SITE DEVELOPMENT PLANS FOR BCS HYATT REGENCY PARKING IMPROVEMENTS

BCS HYATT REGENCY
PARKING IMPROVEMENTS
FDP COVER SHEET

CASE #PL2021-226

BCS HYATT REGENCY
3200 East 81st Street, Bloomington,
MN 55425

SECTION
OUTLET CONTROL STRUCTURE

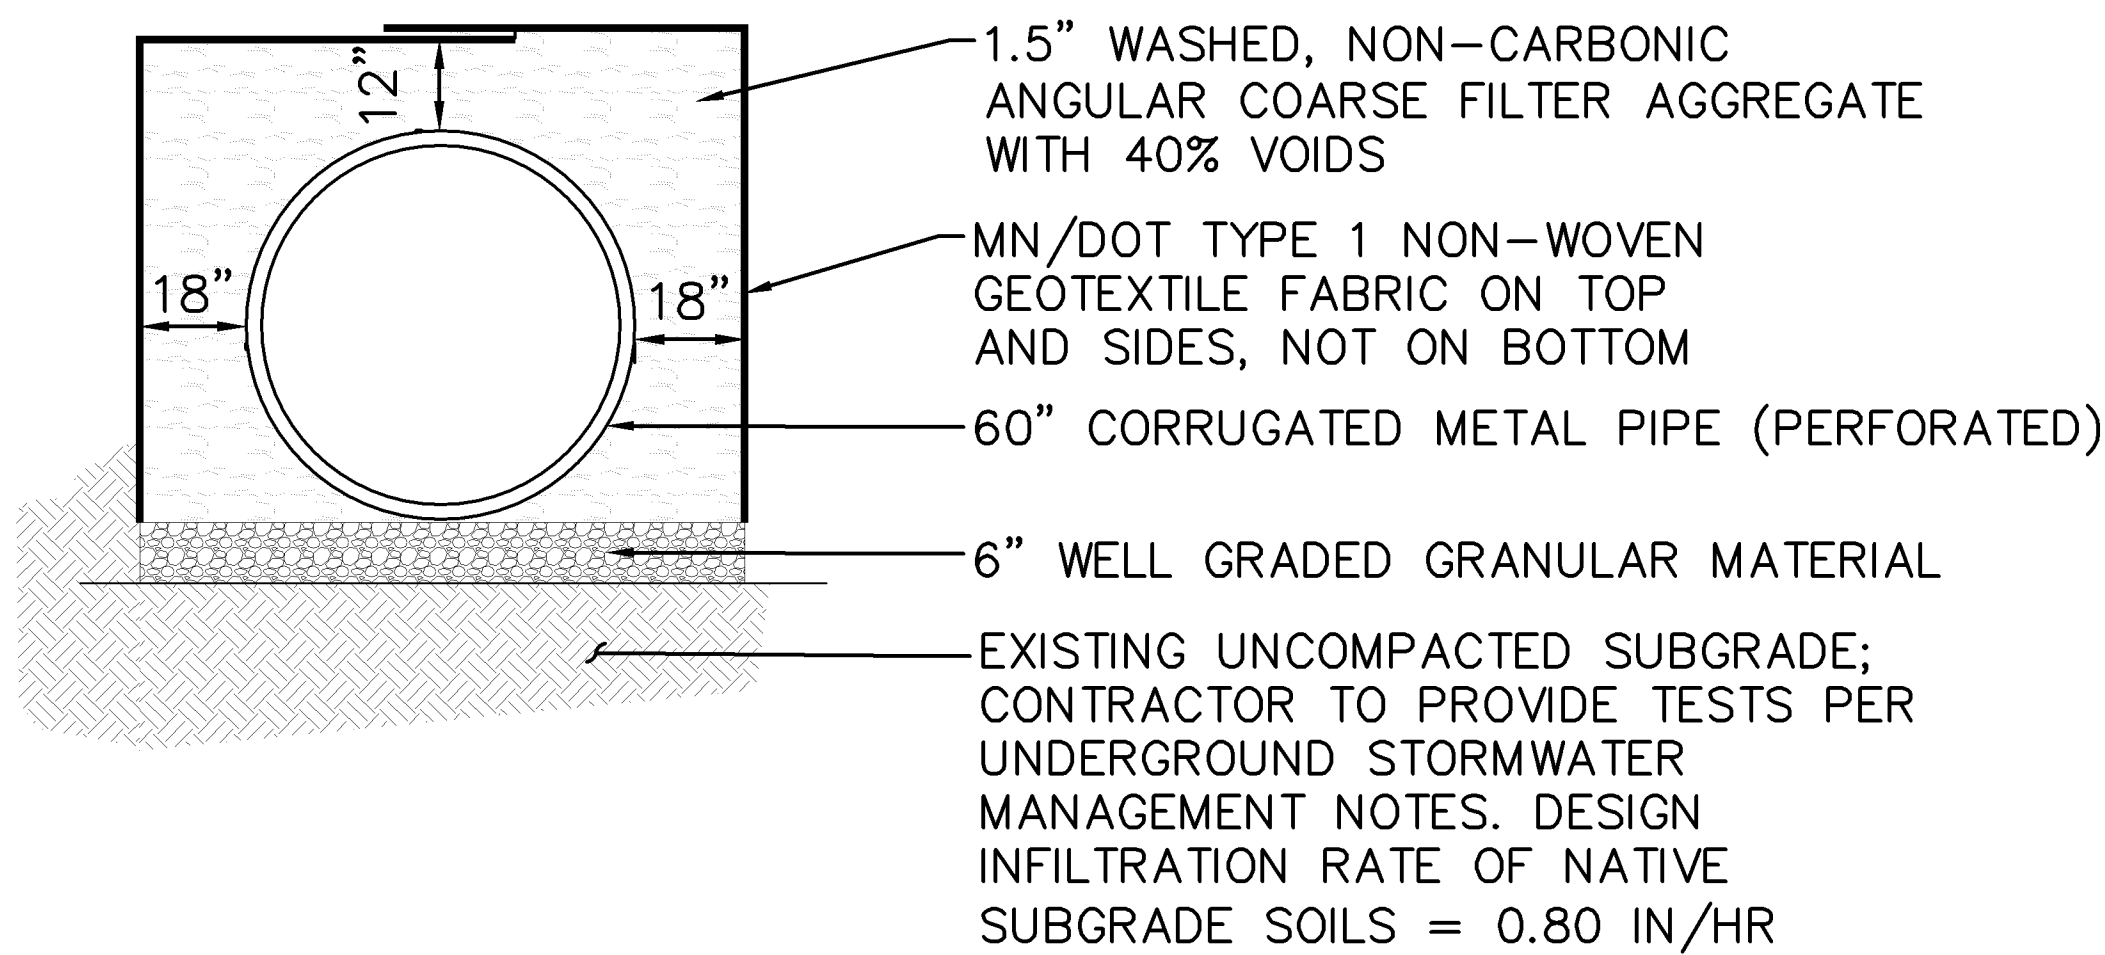
This weir modeled in HydroCAD as 60" width and pipe is specified as ADS. 60" CMP will not fit in a 60" MH and the trench detail does not match the model. Revise detail and/or model to provide clarity.
